12TH MOUNTAIN OFFICES
ALBUQUERQUE, NEW MEXICO

GRADING AND DRAINAGE PLAN

I, John Blasingame, NMPE #12123, of D&P Builders and Engineers, Inc. hereby state that this project, 12th Mountain Offices, has been graded and will drain in substantial compliance with and in accordance with the design intent of the approved plan dated May 13, 2005 (COA). This record information has been obtained by me and is true and correct to the best of my knowledge and belief. This certification is submitted in support of a request for Certificate of Occupancy. I also state that I have personally visited this project on July 7, 2006.

DATE ISSUED: 2-7-2005
 SHEET: C-1

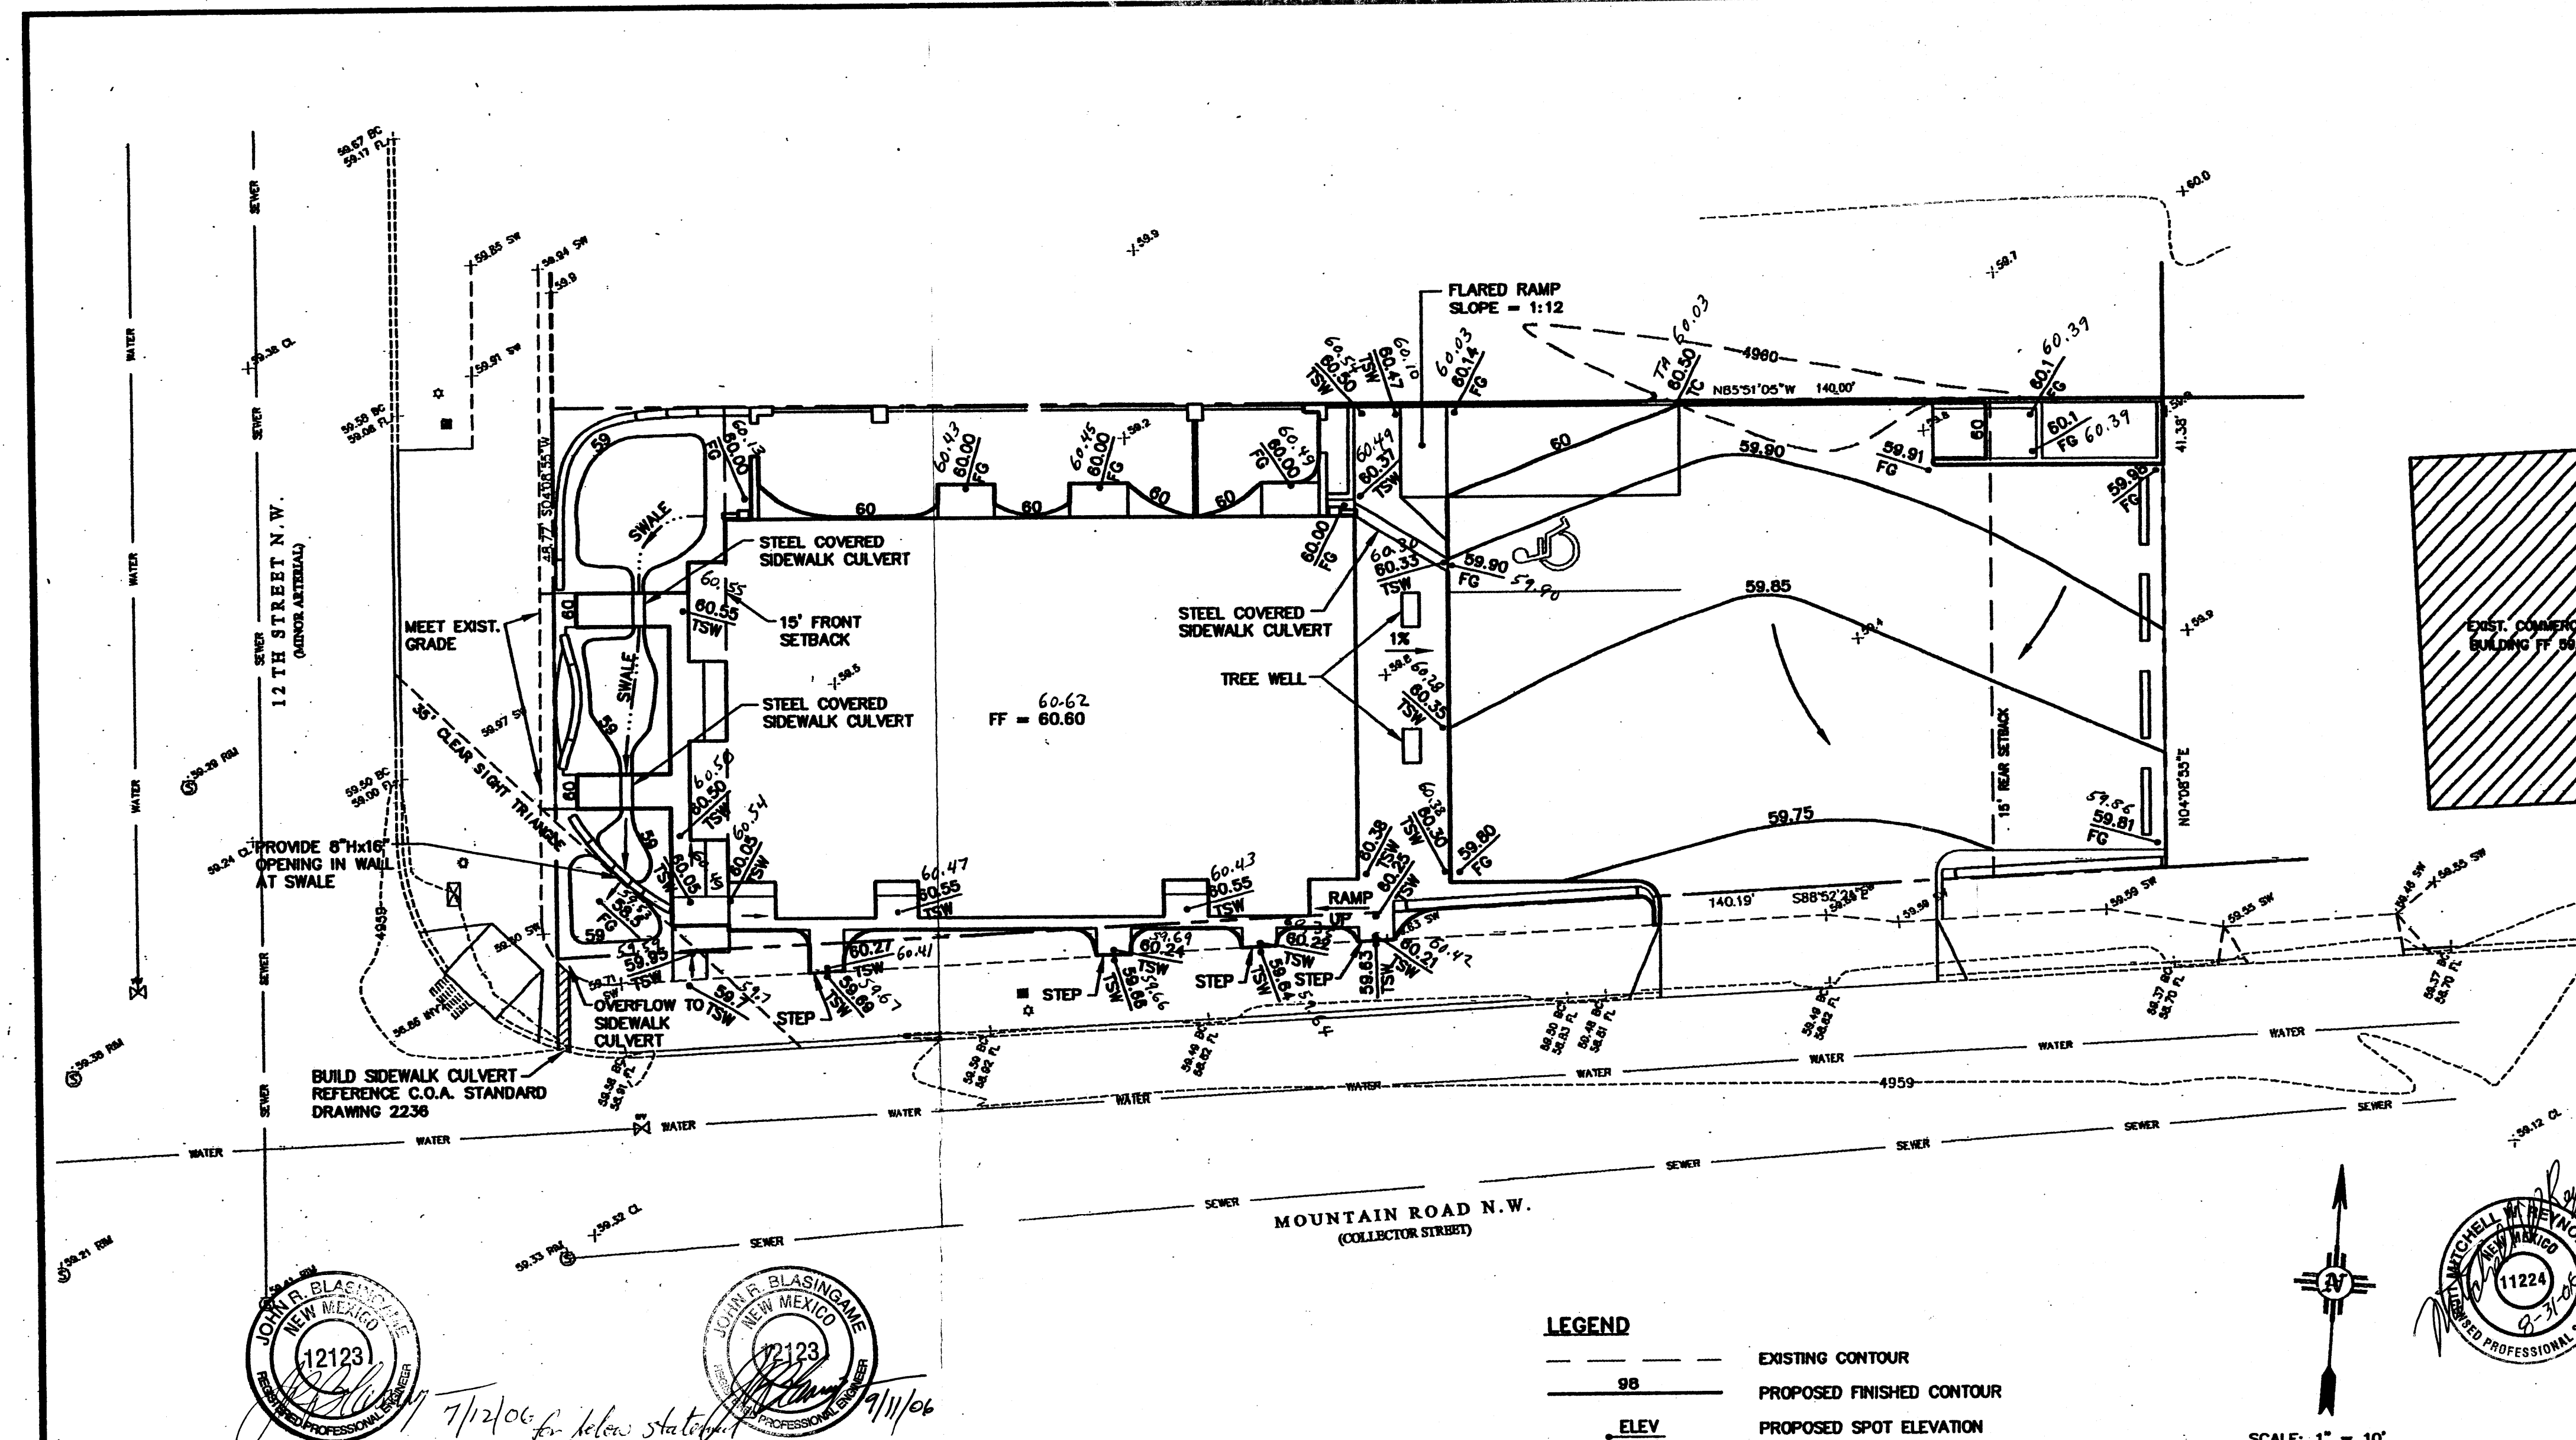
The following items are deficient and are required for completion:

- Construct sidewalk culvert at SW corner of property. See above.
- Construct swales and basins at West side of property. See above.
